BWR OWNERS' GROUP

BWROG-03053
October 23, 2003

Subject: BWR Owner's Group Position On Issues Identified In Generic Safety Issue-189 And The Benefits And Cost Of The Identified Alternatives To Resolving GSI-189 Concerns.

Enclosure: Review of Cost/Benefit for Back-up Power for Mark III Containments under SBO Conditions

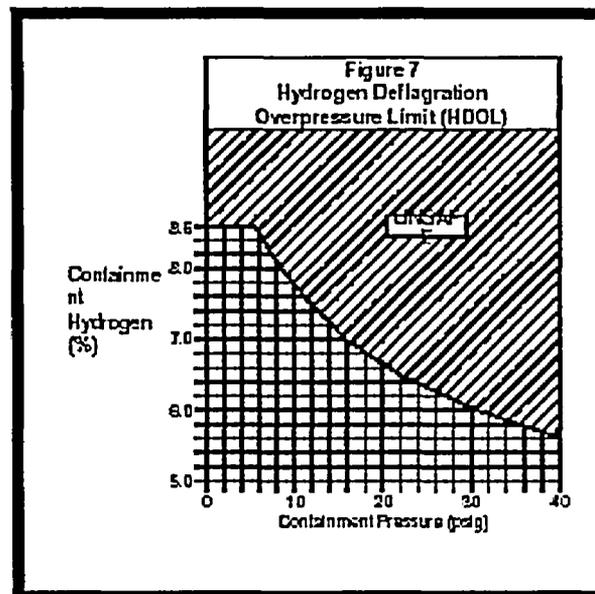
Operation of the Igniters is conditional upon two parameters:

- (1) Containment hydrogen concentration being below the containment HDOL, Figure 7, and
- (2) Drywell hydrogen concentration below the Drywell HDOL of 9%.

Operation of the Igniters with containment hydrogen concentrations above the containment HDOL is prohibited, since a deflagration and the resulting pressure increase under these conditions could overpressurize the containment. Similarly, a deflagration in the drywell, with the drywell HDOL exceeded, could threaten drywell or containment integrity.
